**PRODUCT CHANGE
NOTIFICATION**

SCHURTER
ELECTRONIC COMPONENTS

Product hierarchy no. *				Part no.	SBU		Type / Description	Customer part no.
SBU	PG	PGU	Type					
02	007	023	0000002270	See list below	Appliance inlet 16A		GSP4

GSP4 Appliance Inlet					0118.2310	
creation date	created by	release date	released by	notification no.	revision	page
2015-09-11	hotzar	**2015-10-22**	**hotzar**	**27860**	_	1 of 1

Old marking   New marking

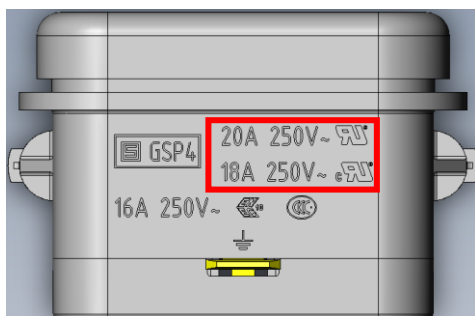
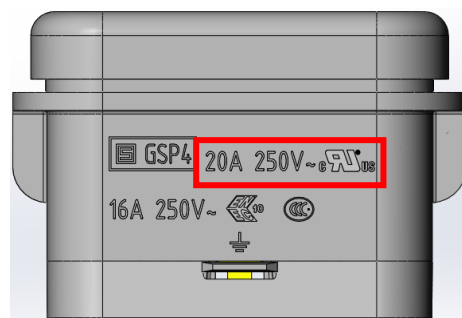
Change of rated current acc.to UL 60320. New rated current for cURus is 20A.
New combined cURus approval mark instead of separate UR and CSA marks.

Form	No	No change in the form
Fit	No	There are no dimensional changes
Function	No	No change in the specification
Production Site	No	There is no change of the production site
Product Label	Yes	CSA and UR marks replaced by cURus mark.
Customer Action	No	No customer action required
